## To CVRD EASC Directors

## Re TELUS Robinson Lake Cell Tower Proposal

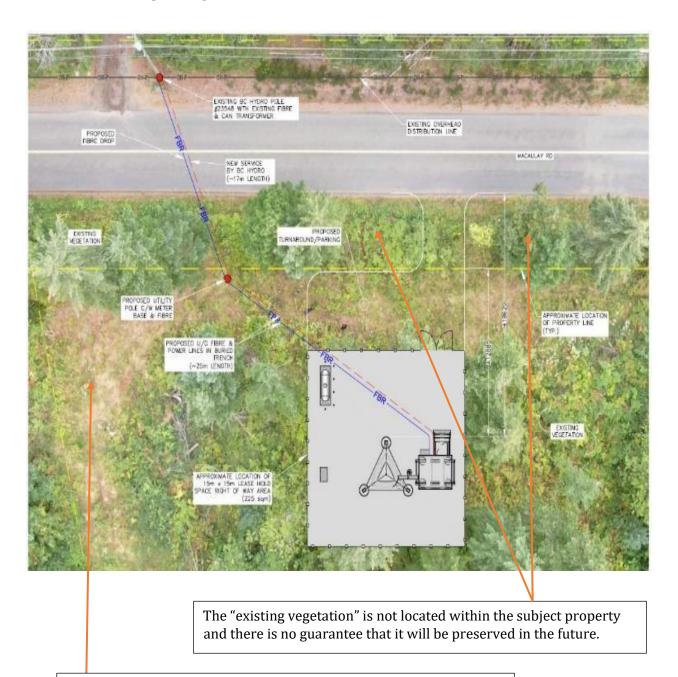
In order to ensure my concerns were correctly represented, I submitted a version of that form to the Area C APC before the meeting, but apparently it was not accepted. I am attaching part of the form here, for your information.
